NORTH FALLS

Offshore Wind Farm

Outline Construction Traffic Management Plan (~~Clean~~Tracked)

Document Reference: 7.16
Volume: 7
Date: ~~April~~July 2025
Revision: ~~4~~3

Drawing 104560-MMD-00-XX-DR-CE-1061_Rev01

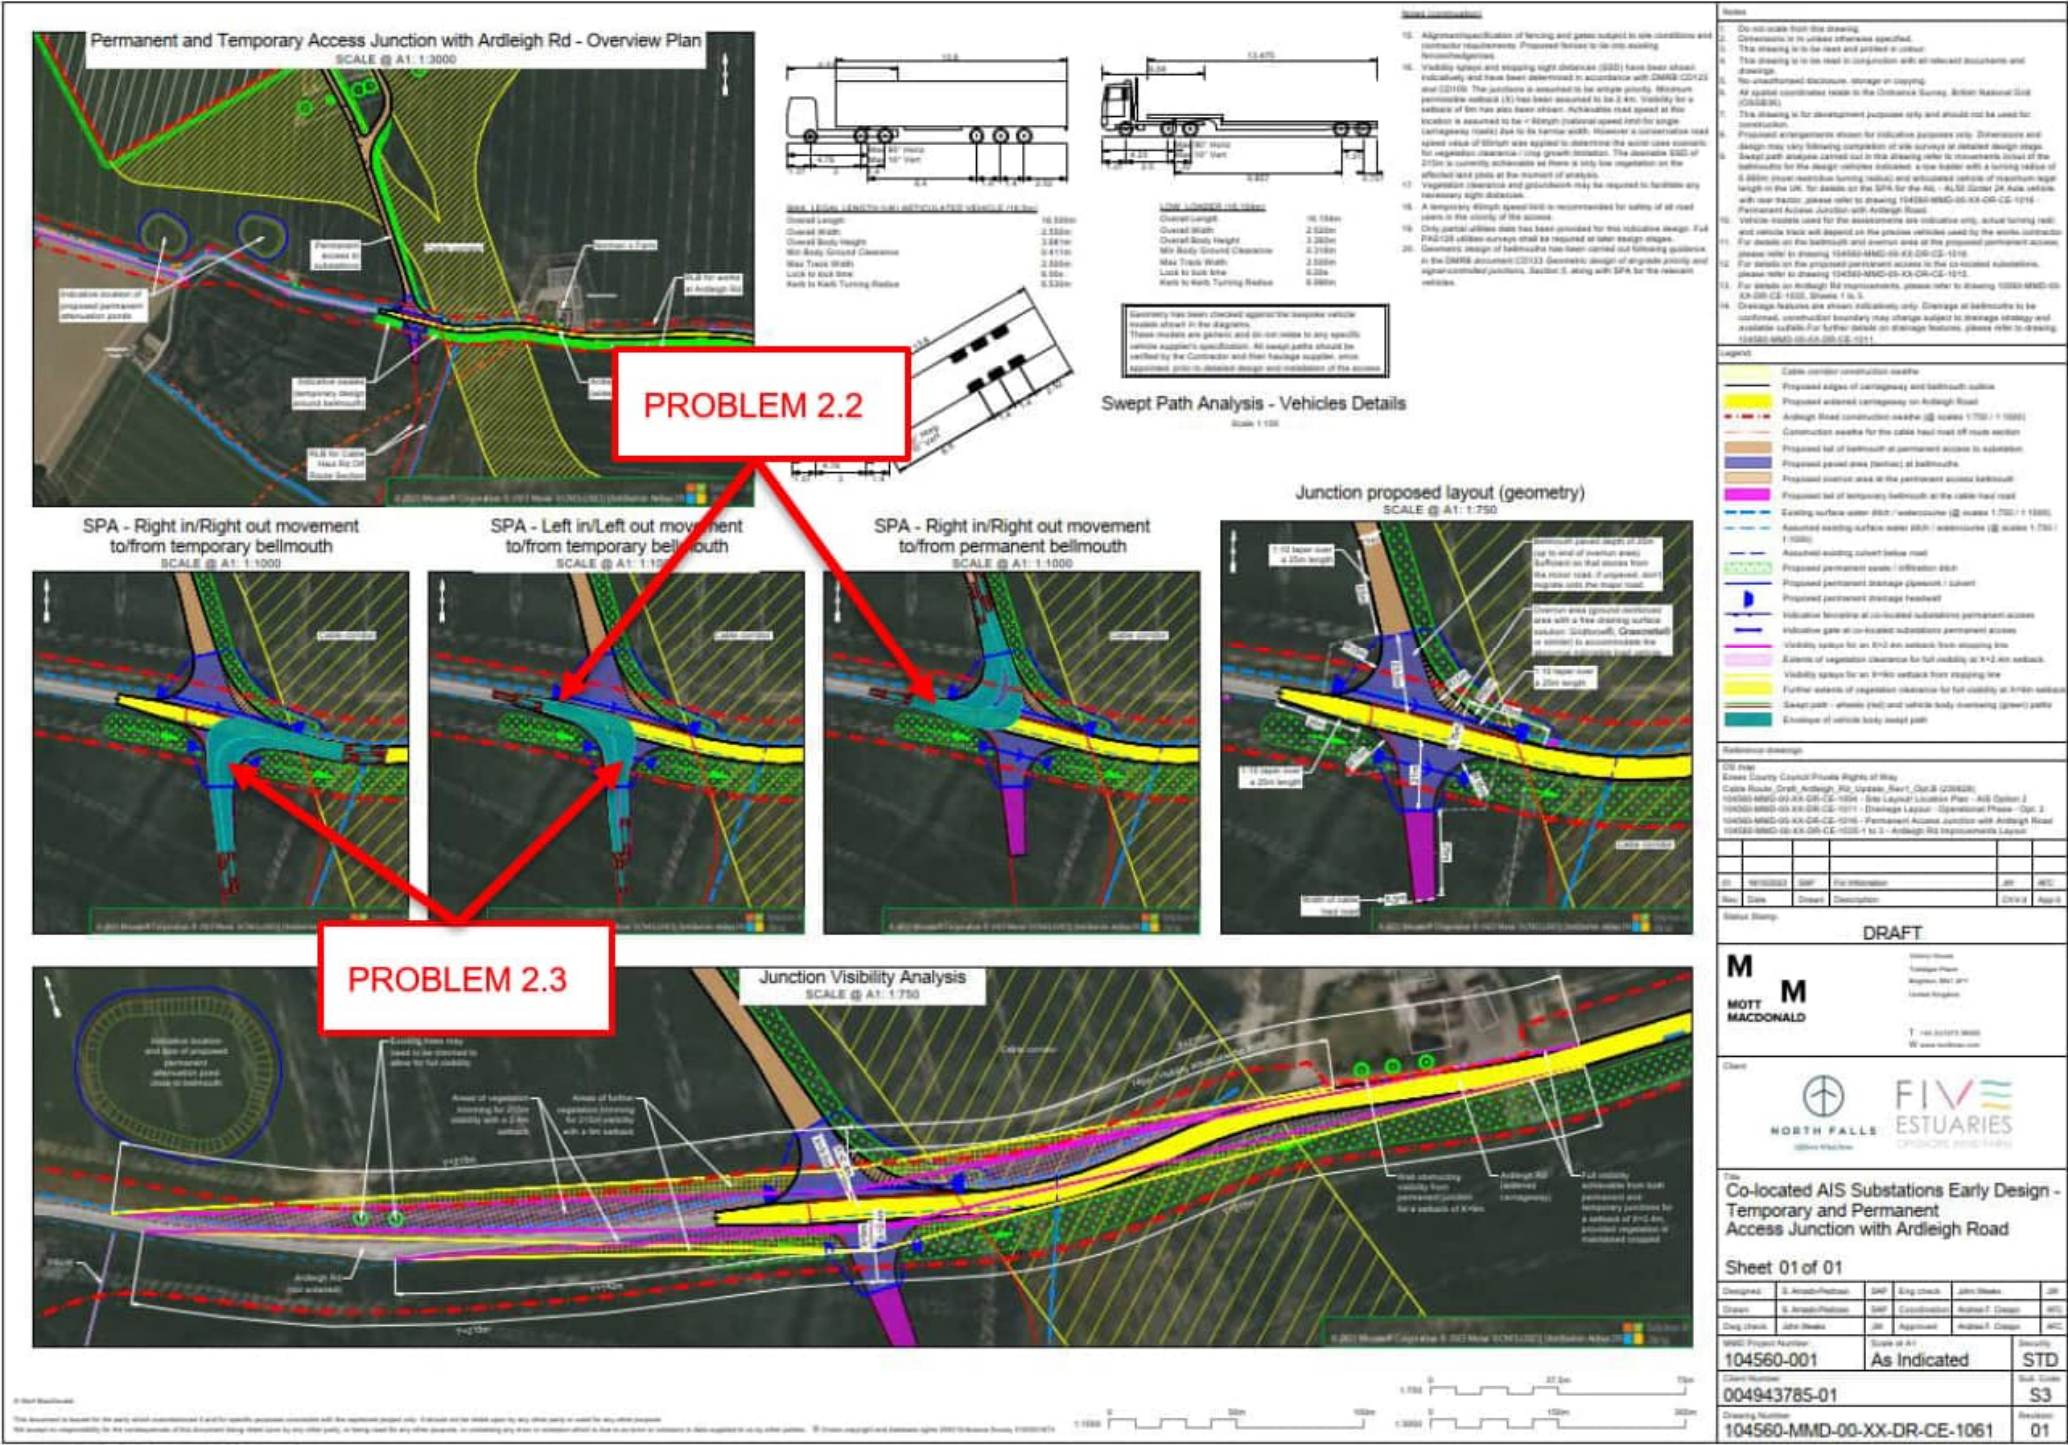
Drawing 104560-MMD-00-XX-DR-CE-1061_Rev01						
2.1	Location: Site Access (Temporary Access Junction with Ardleigh Rd) Summary: Overhead cables may lead to damage to infrastructure, vehicles and occupants. Onsite observations noted the presence of overhead cables that cross Ardleigh Road in various locations in the vicinity of the proposed development. The vertical alignment of proposed HGV access movements may lead to damage to infrastructure or damage to vehicles and injury to occupants.	It is recommended that the vertical assessment is carried out for the appropriate vehicle types to ensure no conflict remains.	● RSA problem and recommendation agreed. ● This matter will be appraised further as an integral part of the detailed design process, when full PAS128 utilities surveys are to be obtained, and drawings detailing diversion or undergrounding (and/or further measures required) of utilities in the vicinity of the proposed access junction and crossing will be developed to take due account of the safety problem and the aligned recommendation. ● A wider utility diversion / undergrounding assessment would need to be carried out by the third party in charge of the Ardleigh Rd improvement works design at the scheme detailed design stage, when full PAS128 utilities surveys shall be completed. Coordination between Mott MacDonald and that third party may be required. ● Notes 9 and 19 in drawing 104560-MMD-00-XX-DR-CE-1061_Rev01 are intended to account for this matter: ● Note 9. «Proposed arrangements shown for indicative purposes only. Dimensions and design may vary following completion of site surveys at detailed design stage». ● Note 19. «Only partial utilities data has been provided for this indicative design. Full PAS128 utilities surveys shall be required at later design stages».	TBC	TBC	This matter will be appraised further as an integral part of the detailed design process, when full PAS128 utilities surveys are to be obtained, and drawings detailing diversion or undergrounding of utilities in the vicinity of the proposed access junction and crossing will be developed to take due account of the safety problem and the aligned recommendation (TBC).

Drawing 104560-MMD-00-XX-DR-CE-1032-1_Rev02

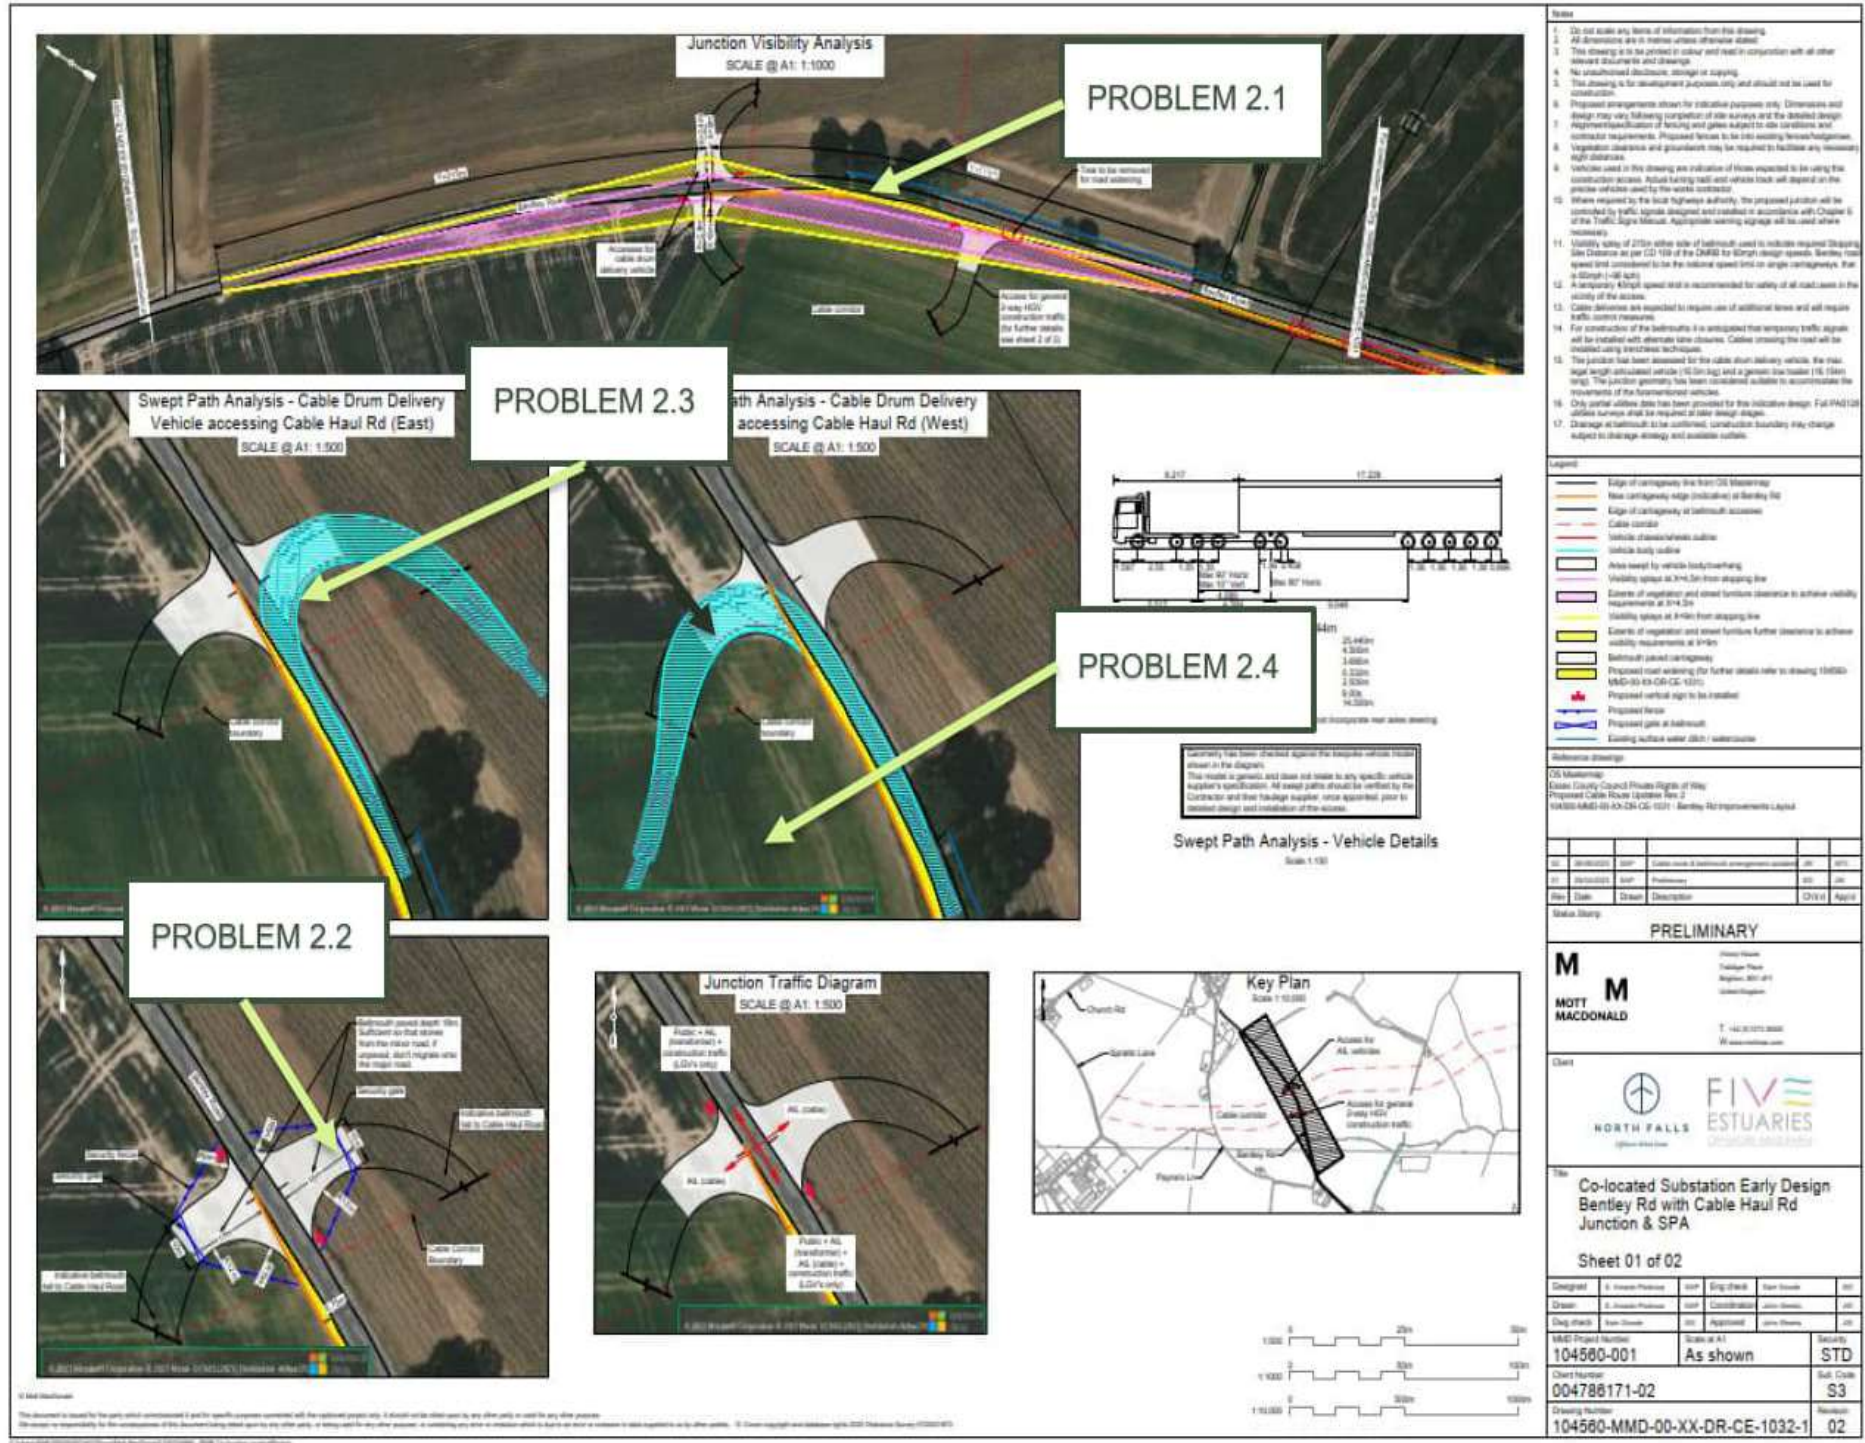
Drawing 104560-MMD-00-XX-DR-CE-1032-1_Rev02						
2.1	Location: Site Access (Temporary Access Junction with Bentley Rd). Refer to Appendix B. Summary: At a 9m setback, existing trees may obscure the visibility splay potentially leading to side swipe type collisions. Onsite observations noted that the presence of existing vegetation may constitute an obstruction to the junction visibility. Obstruction to visibility splays may lead to injudicious vehicle movements at the proposed junction leading to side swipe collisions between vehicles.	It is recommended that the trees be cut back and maintained as such that it does not pose an obstruction to the visibility splays.	● RSA problem and recommendation acknowledged but not agreed since it is not considered that these trees have an impact on the visibility clearance areas. The visibility splay with a 9m setback on the eastern side of Bentley Rd (northern side of Bentley Rd on drawing 104560-MMD-00-XX-DR-CE-1032-1) only captures a small area of road verge west of these existing trees, to run across the road to the other verge side west of Bentley Rd (South of Bentley Rd in drawing 104560-MMD-00-XX-DR-CE-1032-1). Cutting back or trimming the trees will not produce any changes to visibility. Trees are located on the southeast of the road and will cast shadow during most part of the day unless they are totally cut. ● In drawing 104560-MMD-00-XX-DR-CE-1031-3 for the same scheme (refer to Appendix C in this document), it is indicated the trimming of these existing trees to facilitate passage of vehicles, which will also help with general visibility. ● No designer action proposed.	TBC	TBC	No action (TBC).

Ref.	RSA Problem	RSA Recommendation	Design Organisation Response	Audit Team Supplementary Comment	Client / Project Sponsor Comment	Agreed RSA action
			envelope, fits within the bellmouth outlines. The chassis envelope line will be brought forward in the drawing for clarity. - Also please note that vehicle models used to perform the SPA are conservative and representing a worst case scenario. We can conclude that if the vehicle chassis swept path fits within the carriageway limits with these conservative vehicle models (as it does), room is to be sufficient in reality. - Note 9 in drawing 104560-MMD-00-XX-DR-CE-1032-1_Rev02 («Vehicles used in this drawing are indicative of those expected to be using this construction access. Actual turning radii and vehicle track will depend on the precise vehicles used by the works contractor») and disclaimer shown in Vehicle Details («This model is generic and do not relate to any specific vehicle supplier's specification. All swept paths should be verified by the Contractor and their haulage supplier, once appointed, prior to detailed design and installation of the access») were included as caveats in relation to this matter.

Drawing 104560-MMD-00-XX-DR-CE-1032-2_Rev01

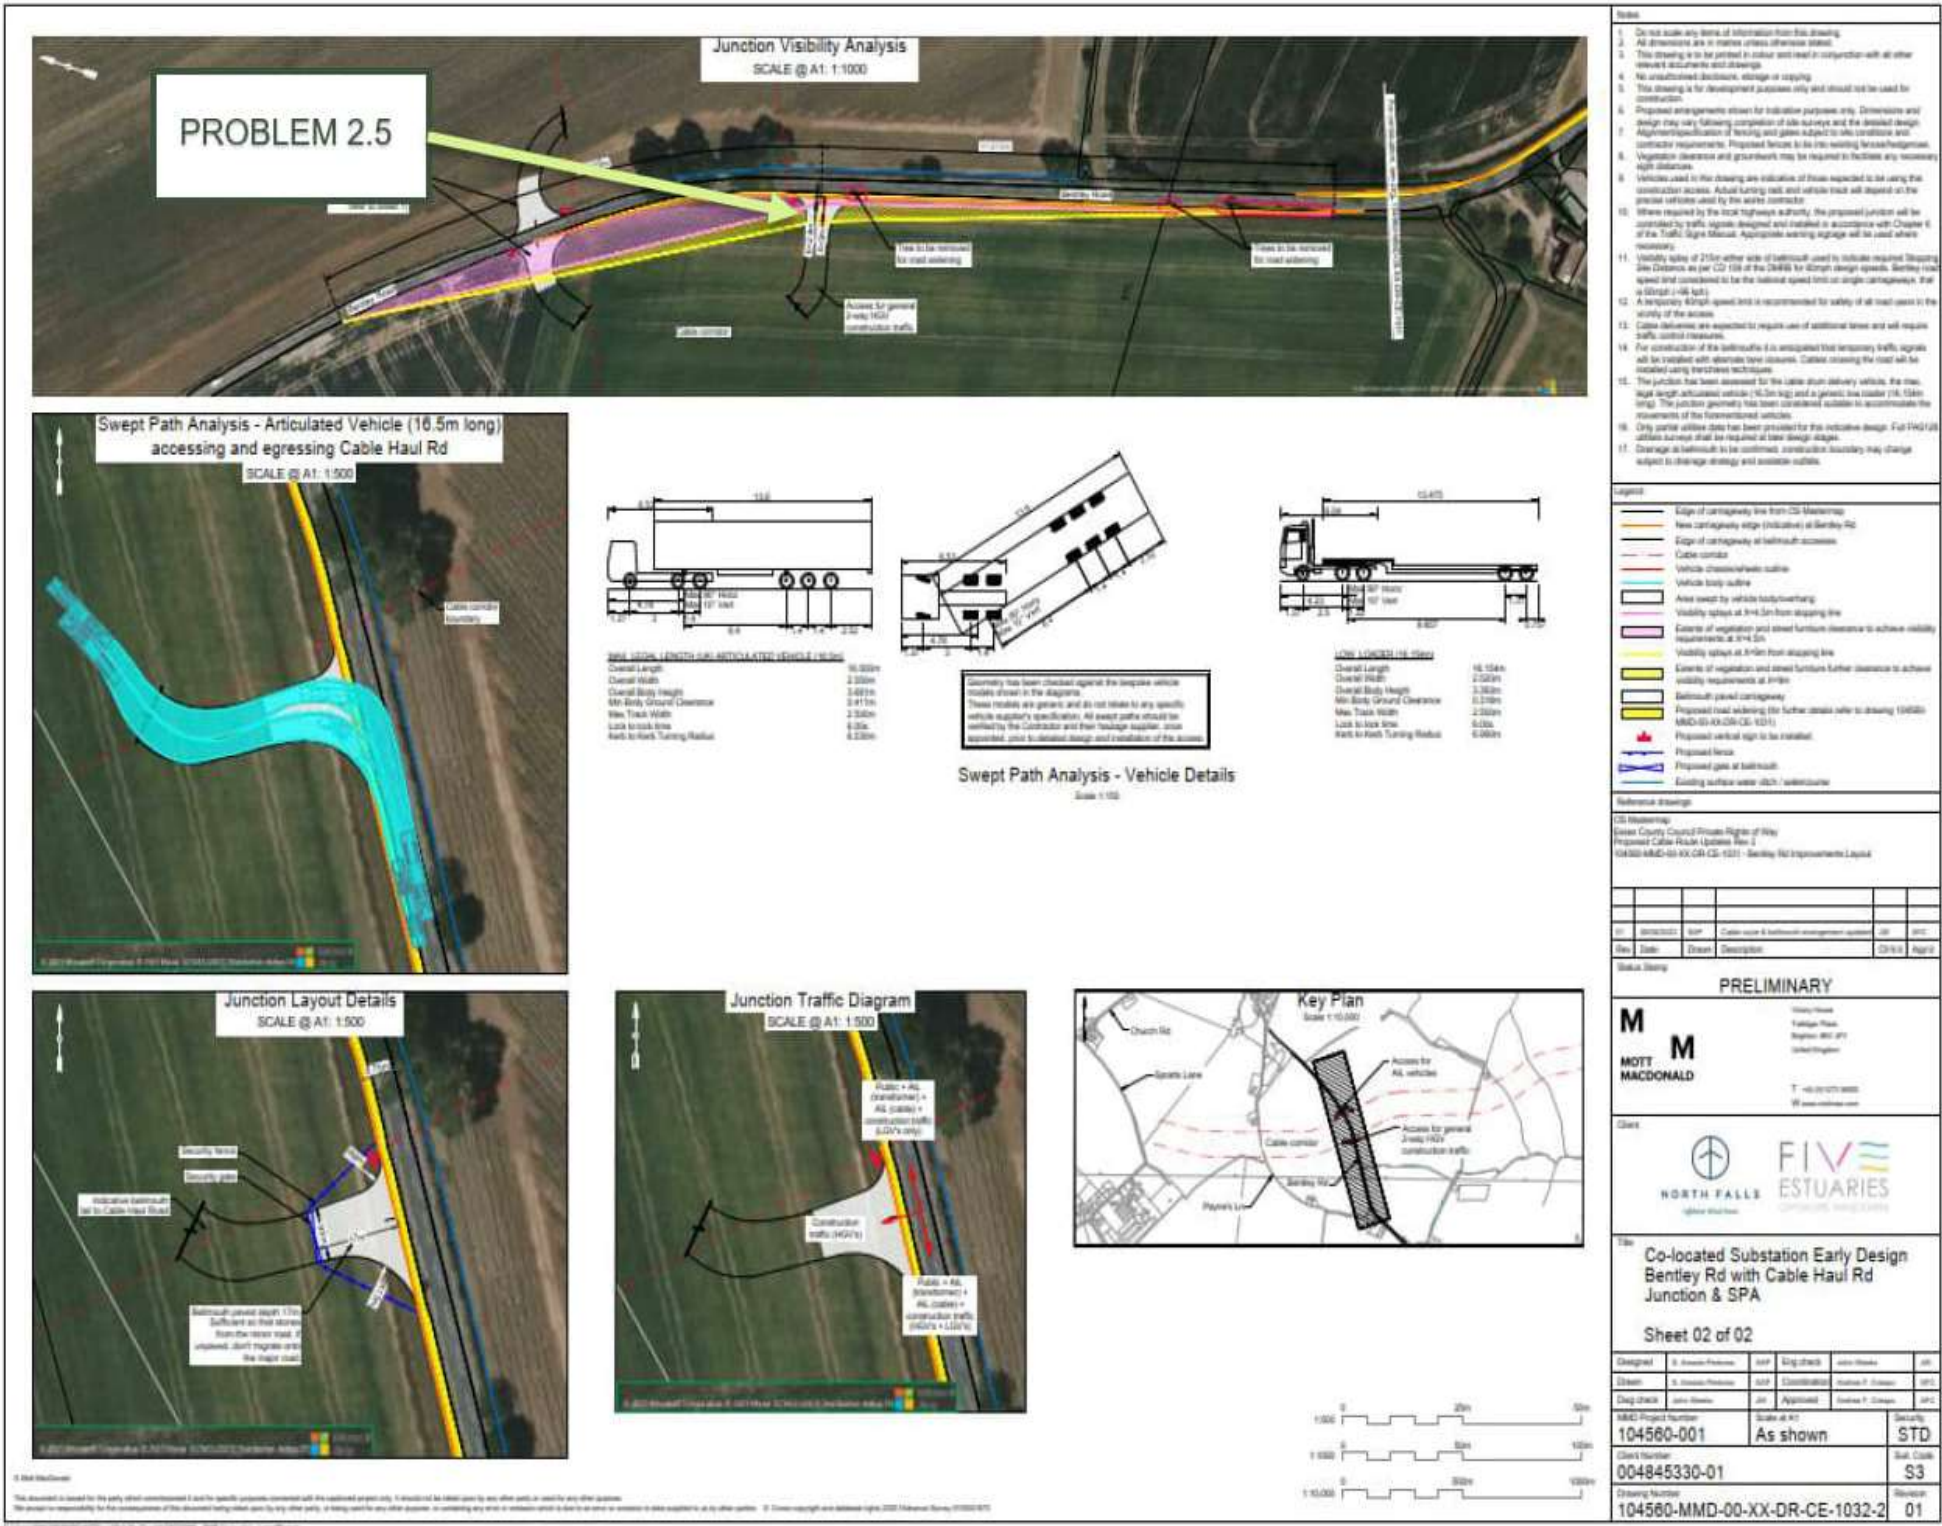
Drawing 104560-MMD-00-XX-DR-CE-1032-2_Rev01						
2.5	Location: Proposed site access. Refer to Appendix B. Summary: The level difference between the carriageway and site could result in loss of control or side swipe type collisions. Onsite observations found that there was a difference in levels between the existing carriageway and the new access. An excessive gradient may create difficulty for large construction vehicles wishing to access Lodge Lane and may in turn lead to a lack of surface friction and slow egress movements potentially creating shunt / side swipe type collisions between egressing construction vehicles and vehicles travelling on Bentley Road.	It is recommended that the existing gradient be amended to an appropriate level for the restart movements of large vehicles accessing Bentley Road from the proposed site	- RSA problem and recommendation agreed. - This matter will be appraised further as an integral part of the detailed design process and drawings developed to take due account of the safety problem and the aligned recommendation.	TBC	TBC	This matter will be appraised further as an integral part of the detailed design process and drawings developed to take due account of the safety problem and the aligned recommendation. (TBC)
